Subject: Quad Cities Station Units 1 & 2  
Second Ten Year Inservice Inspection Program  
Request for Additional Information  
NRC Docket No. 50-254 & 50-265

RESPONSE TO  
REQUEST  
FOR  
ADDITIONAL  
INFORMATION

RESPONSE TO REQUEST FOR ADDITIONAL INFORMATION  
INSERVICE INSPECTION PROGRAM

Figure 6

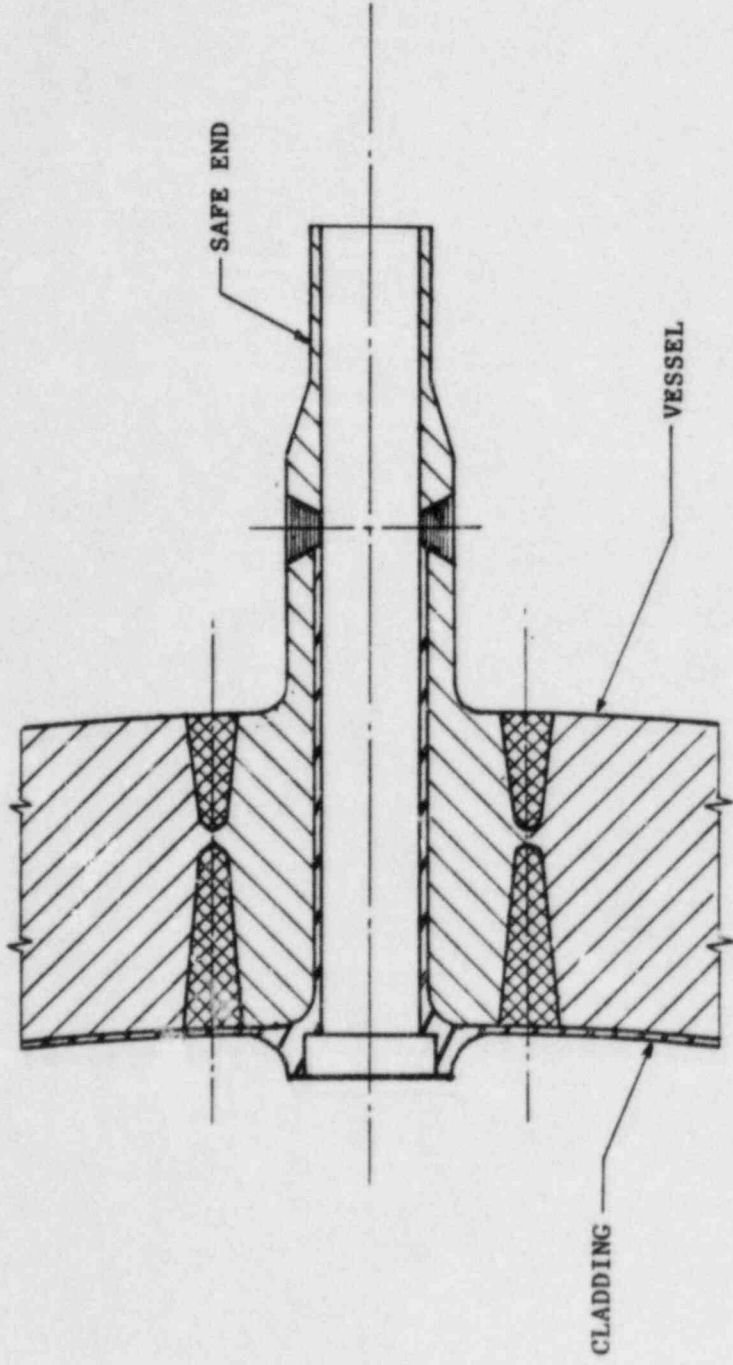
Section XI of the 1980 Edition of the ASME Code including the Winter 1980 Addenda specifies that a volumetric inspection of all full penetration nozzle inside radii sections (code category B-D, item B3.100) each ten-year interval.

The design of the Standby Liquid Control (SBLC) Nozzle as shown on Figure 6 provides an inner radius geometry which is not conducive to ultrasonic inspection.

Relief is requested from this SBLC inner radius inspection due to the nozzle inside radius geometry.

The design of the SBLC nozzle piece does not lend itself to ultrasonic inspection. The nozzle as shown on figure 6 has an integral socket to which the boron injection piping is fillet welded and consequently provides a geometry which will result in a meaningless ultrasonic examination.

No alternate or augmented examinations are feasible at this time.
